Project	<b>IEEE 802.16 Broadband Wireless Access Working Group</b> < <a href="http://ieee802.org/16">http://ieee802.org/16</a> >	
Title	<b>Illustration of the frame structure for a 16m TDD system with four switching points</b>	
Date Submitted	<b>2008-05-13</b>	
Source(s)	Per Ernstrom, Per-Erik Östling Ericsson AB SE-164 80 Stockholm, Sweden  Lei Wang Nextwave Wireless	E-mail: Per.Ernstrom@ericsson.com, Per-Erik.Ostling@ericsson.com Lwang@nextwave.com
Re:	The call for contributions on “The entire content of IEEE 802.16m-08/003r1” (Frame structure)	
Abstract	Multiple sections of the documents contain text proposals in support of comment submitted separately on the proposed frame structure baseline content in document C802.16m-08/118r1.	
Purpose	Propose text changes to the SDD in support of a comment to IEEE 802.16m-08/003r1 (SDD) submitted separately	
Notice	<i>This document does not represent the agreed views of the IEEE 802.16 Working Group or any of its subgroups. It represents only the views of the participants listed in the “Source(s)” field above. It is offered as a basis for discussion. It is not binding on the contributor(s), who reserve(s) the right to add, amend or withdraw

Figure X Example of sub-frame configuration in TDD duplex scheme with four switching points per radio frame.

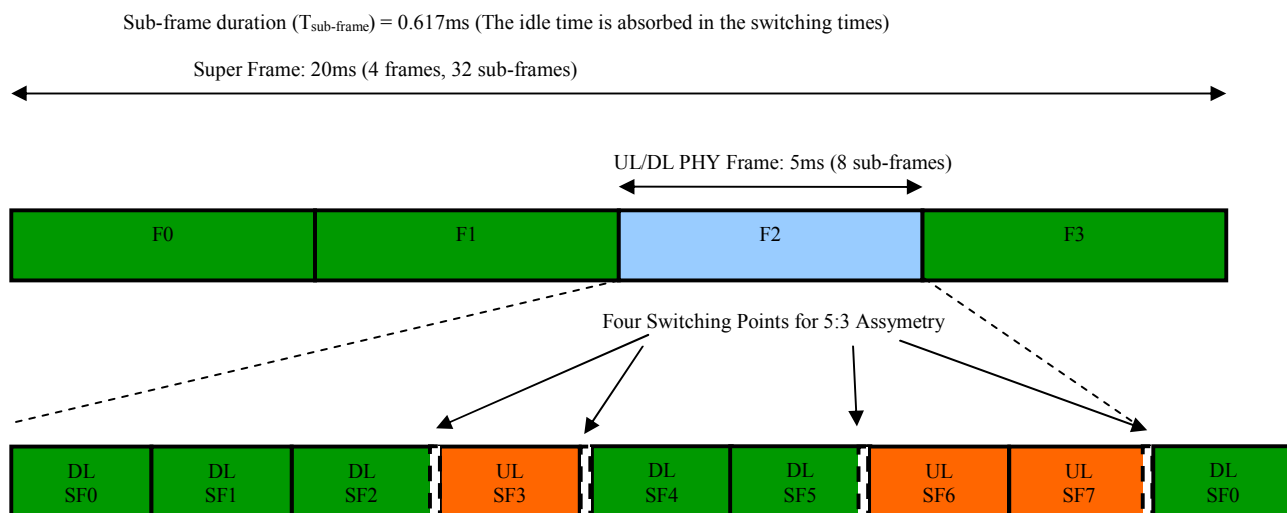
In the SDD (802.16m-08/003r1), in section 11.4.1 on the Basic Frame Structure, it is stated that the number of switching points in each radio frame is between two and four for TDD systems. There is, however, no illustration of the four switching point case. We believe that such an illustration would be helpful for further work, and propose therefore the introduction of such a figure, and associated text.

Change the paragraph in line 23 to 27 on page 17 as follows:

Figure 9 and figure X illustrates ~~an~~ example TDD frame structures with DL to UL ratio of 5:3, for two and four switching points respectively. Assuming OFDMA symbol duration of 102.82 us and a CP length of 1/8 Tu, the length of regular and irregular sub-frames are 0.617 ms and 0.514 ms, respectively. Other numerologies may result in different number of sub-frames per frame and symbols within the sub-frames. Figure 10 shows the frame structure in FDD mode.
